FIRE SAFETY INSPECTION REPORT

Green Smart Shirts Ltd

ACCORD ID: 23220

Date: 30, April 2018

3

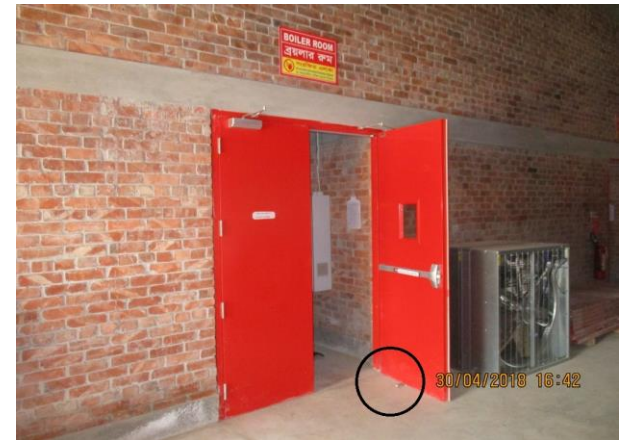
Generator/boiler/compressor/switchgear rooms are not properly separated by fire rated construction with other occupancy. Unsealed penetrations have observed on the rated wall. Even fire doors have found open by external objects.

Location: Ground floor, Utility Building

Generator/boiler/compressor/switchgear rooms shall be separated from other occupancies by a minimum 2-hr fire rated construction (wall, floor, slab etc.). Seal all penetrations and openings (door, window etc.) should be protected by 1.5-hr fire rated materials to maintain the fire separation if required. All exhaust systems shall discharge to the exterior of the building in a safe location.

If fire doors are required to be held open for functional reasons, provide automatic-closing devices tied to the fire alarm system.
